Technical Service Bulletin: tsb100885

Released Date: 27-Mar-2017

New Eliminator™ Bracket

Figure 1: New Eliminator™ Support Bracket Assembly

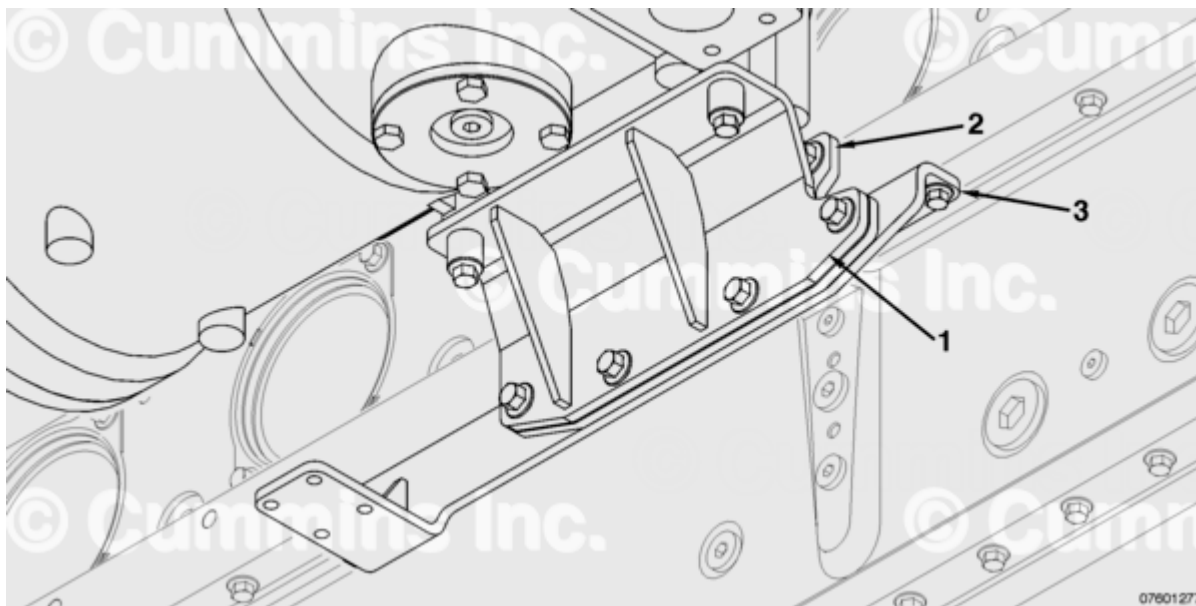
This Service/Parts Topic announces the release of a new Eliminator™ bracket for use on the QSK 60 engine.

The bracket has been redesigned from a single piece bracket to a three piece bracket to increase robustness.

Figure 1 shows an assembly of the new three piece bracket.

Table 1 shows the old part number, new part numbers, and ESN first.

Engine Model	Old Part Number	New Part Number	Item Number	ESN First
QSK60	4016424	3642189	1	33179329
		3642188	2	
		3642187	3

Figure 2; Mounting Components

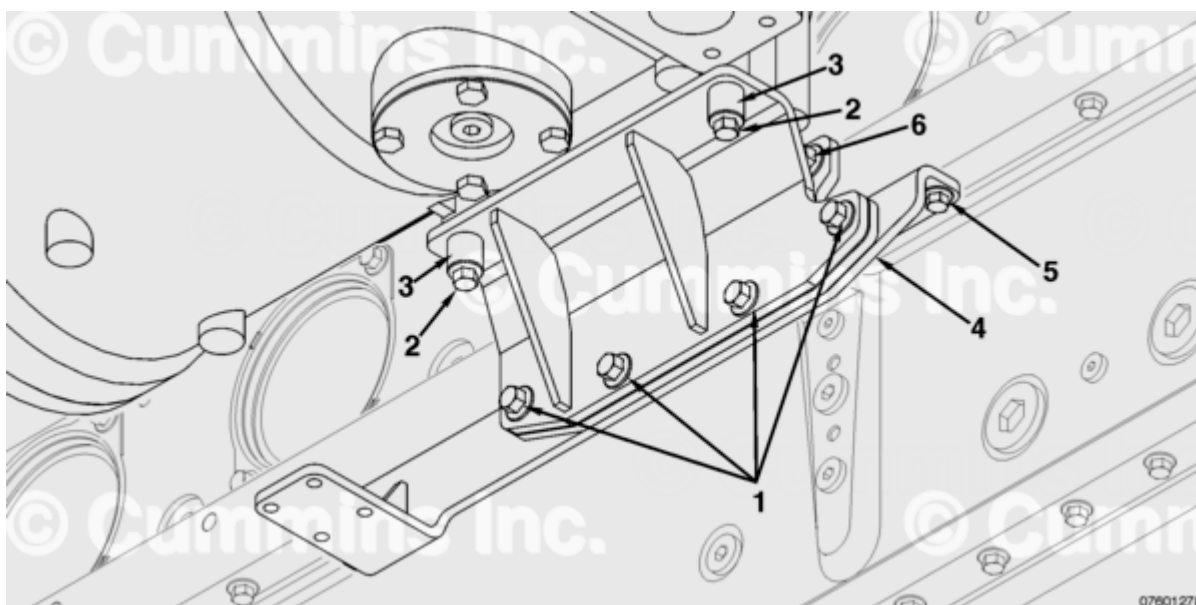
Figure 2 shows where the mounting components are positioned.

Table 2 shows the mounting components that are required to upfit an engine with the new Eliminator™ support bracket assembly.

Table 2, Mounting Components			
Part Number	Description	Item Number	Quantity
3903464	M10 x 1.5 (40 mm length)Capscrew	1	4
3902116	M12 x 1.75 (50 mm length) Capscrew	2	2
3631782	Spacer	3	2
3902662	M10 Nut	4	4
3900635	M10 x 1.5 (60 mm length) Capscrew	5	5
3910495	M12 x 1.75 (30 mm length) Capscrew	6	2

Date	Details
2017-3-27	Capscrew, Part Number 3900635, quantity updated from 4 to 5.
